MISSISSIPPI DEPARTMENT OF TRANSPORTATION

SUPPLEMENT TO SPECIAL PROVISION NO. 907-618-4

DATE: 11/16/2022

PROJECT: NHPP-0015-02(130) / 108936301 MP-6084-34(011) / 307890301 – Jones County

R16-3 signs shall be spaced in accordance with sheet titled "Location of R16-3 Signs".

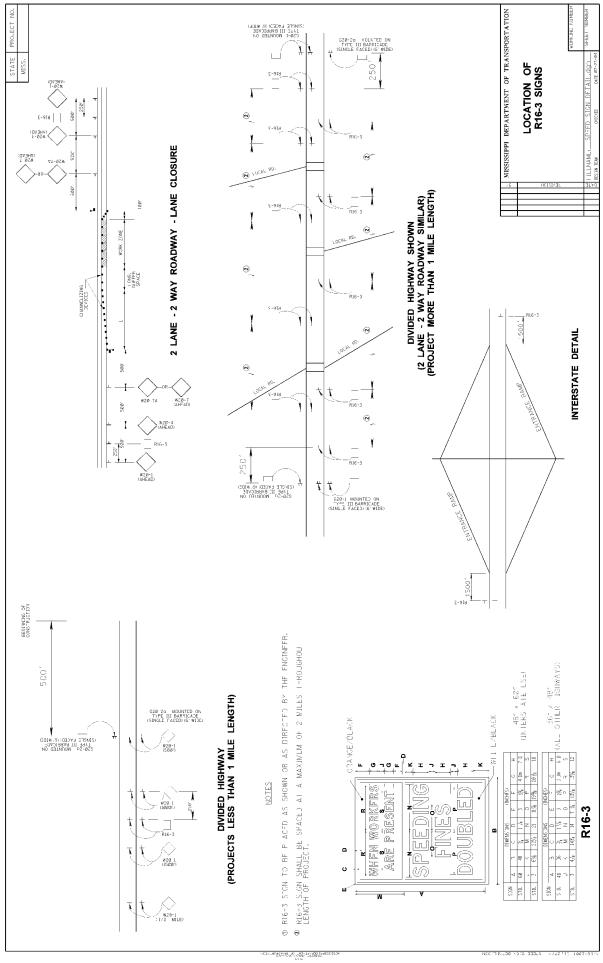
After the first paragraph of Subsection 907-618.01.2 on page 1, add the following.

Additional traffic control devices will be required as follows.

ADDITIONAL TRAFFIC CONTROL SIGNS REQUIRED:

- 45 W20-1 "AHEAD" signs required. One (1) sign is required at each local road or street entering the project.
- 28 R16-3 "SPEEDING FINES DOUBLED" signs required.

All construction signs and barricades shown on this page shall be included in the bid price for Pay Item 618-A, Maintenance of Traffic. Fluorescent orange sheeting shall be used on all construction and traffic control signs except for R16-3 which shall be black legend and border on white background.
